Memorandum

Subject: Response to County of Santa Clara's Review Comments Regarding Intuitive

Surgical's Revised Site Plan in Sunnyvale and Santa Clara, California

Re: Response to Comments from the County and City of Santa Clara on the Memo Addressing Intuitive Surgical's Revised Site Plan in Sunnyvale and Santa Clara, California

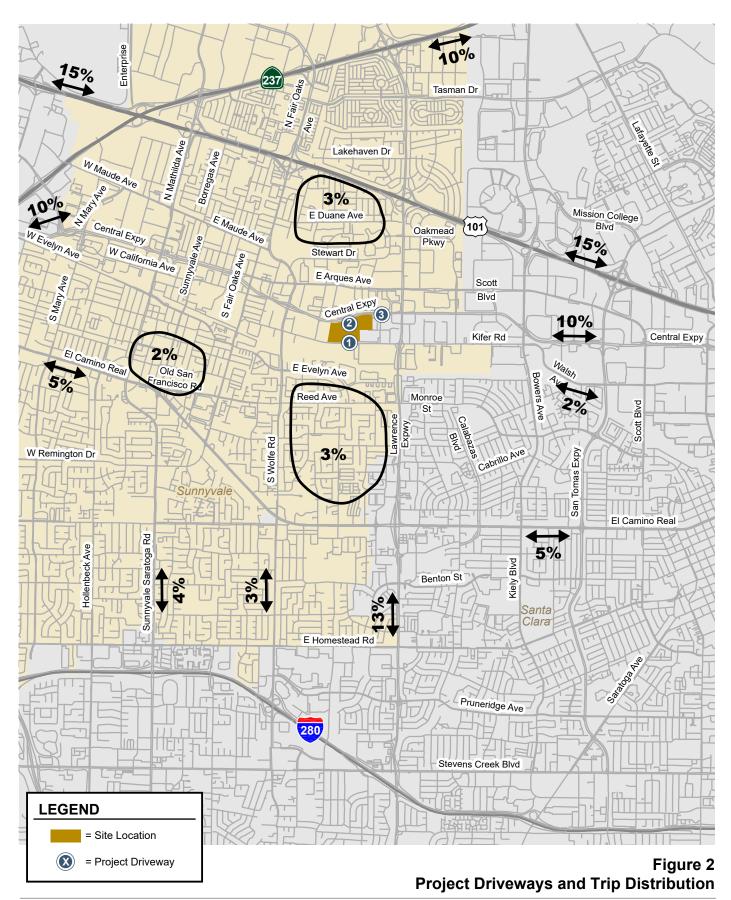
1. **Comment:** Kifer Road/ Project Driveway (Intersection #1) should be a 4-leg intersection and Could you revise the map to reflect that?

Comment: The trip distribution and assignment should be looked over again and modified
as it seems that vehicle trips would utilize Central Expressway instead of Kifer Road to
access the project site. The travel time on Kifer Road would be much slower and less
attractive to vehicle trips than taking Central to access the site.

Response: The figure was revised in the memo.

Response: Google Maps showed that the travel times and distances between the paths using the driveways on Central Expressway versus Kifer Road are similar. It would also be a conservative approach to assign trips onto the local roadway network.

Figure 4A Project Site Gate Locations

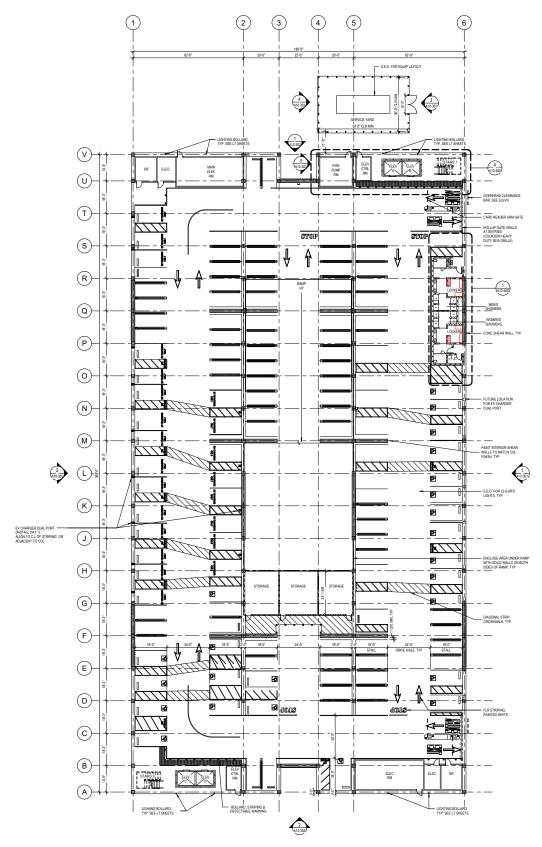
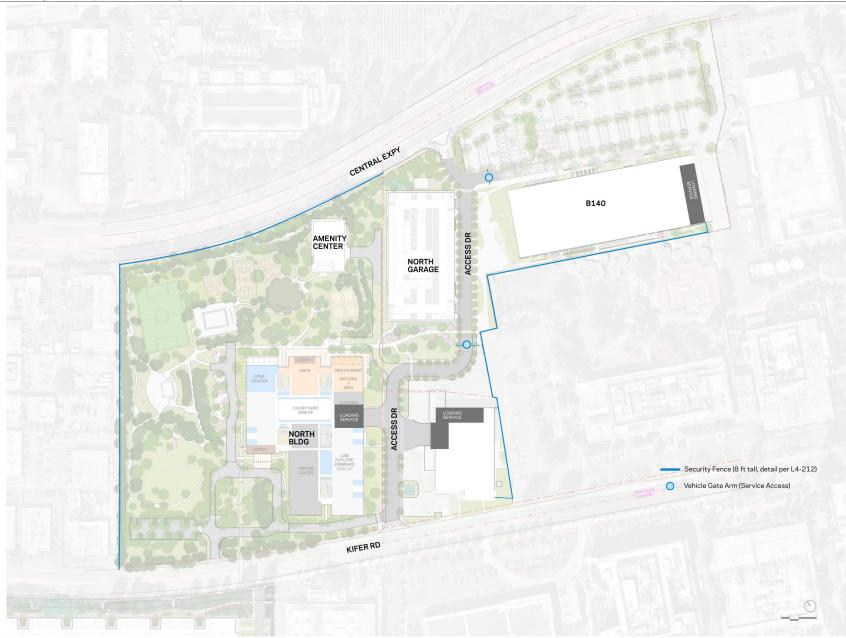
3. **Comment:** Please show where the gates would be located for both parking structures on the site plan as it is mentioned in the memo that remote controlled gates would be included at the entrances to the stand-along parking garage and the surface lot on the site.

Response: Figures showing the gate locations were added to the memo.
